STATEMENT OF STAFF APPROVAL OF PROPOSED CHANGE

WILDFLOWER LARKSPUR ENERGY FACILITY (01-EP-01C)

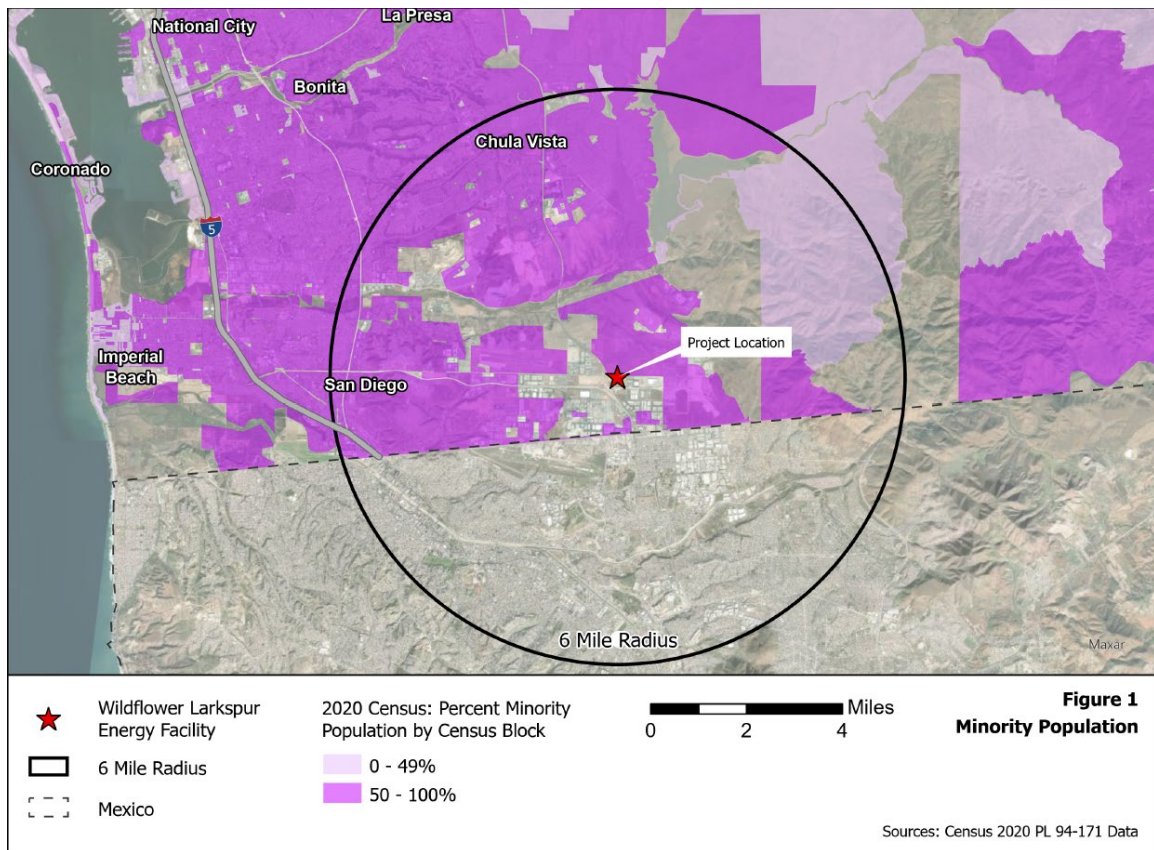
Environmental Justice – Figure 1 shows 2010 census blocks in the six-mile radius of the LEF site with a minority population greater than or equal to 50 percent. The population in these census blocks represents an environmental justice (EJ) population based on race and ethnicity as defined in the United States Environmental Protection Agency’s *Guidance on Considering Environmental Justice During the Development of Regulatory Actions*. Staff conservatively obtains demographic data within a six-mile radius around a project site based on the parameters for dispersion modeling used in staff’s air quality analysis. Air quality impacts are generally the type of project impacts that extend the furthest from a project site. Beyond a six-mile radius, air emissions have either settled out of the air column or mixed with surrounding air to the extent the potential impacts are less than significant. The area of potential impacts would not extend this far from the project site for most other technical areas included in staff’s EJ analysis.

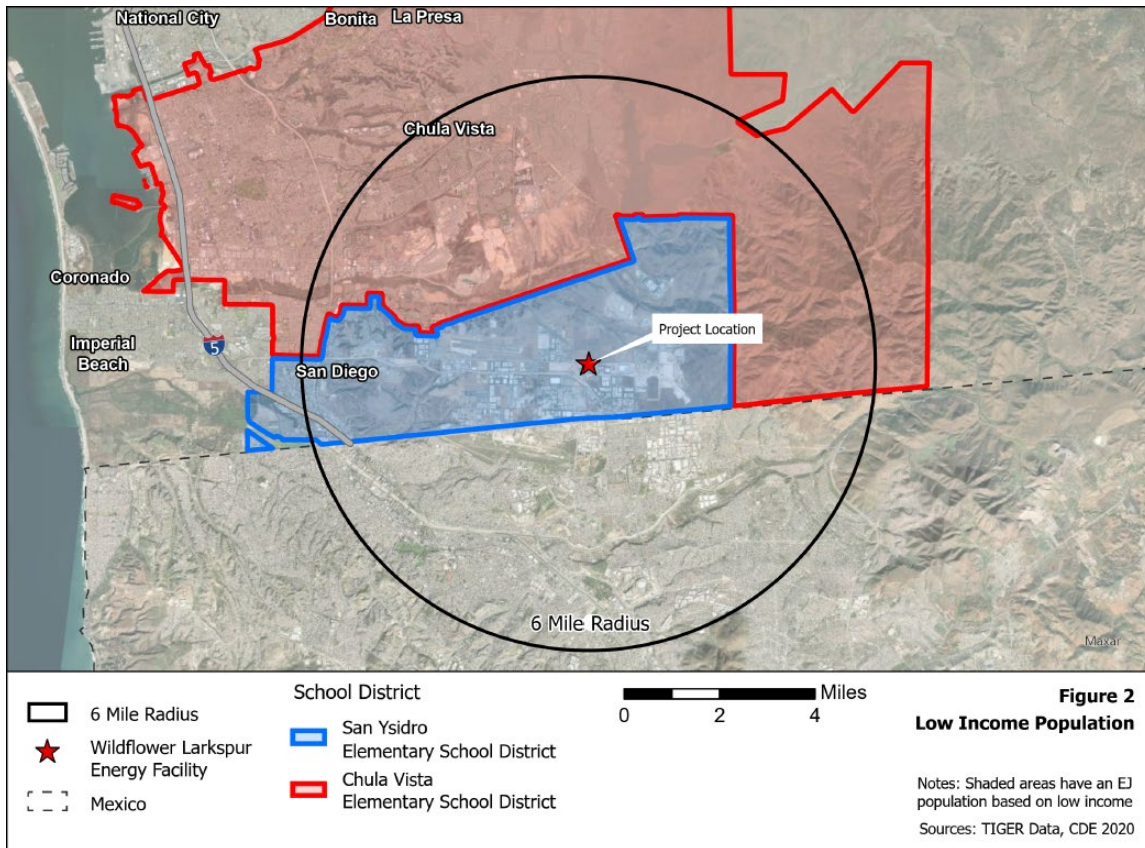
Environmental Justice – Figure 2 shows where the boundaries of the school districts are in relation to the six-mile radius around the LEF site.
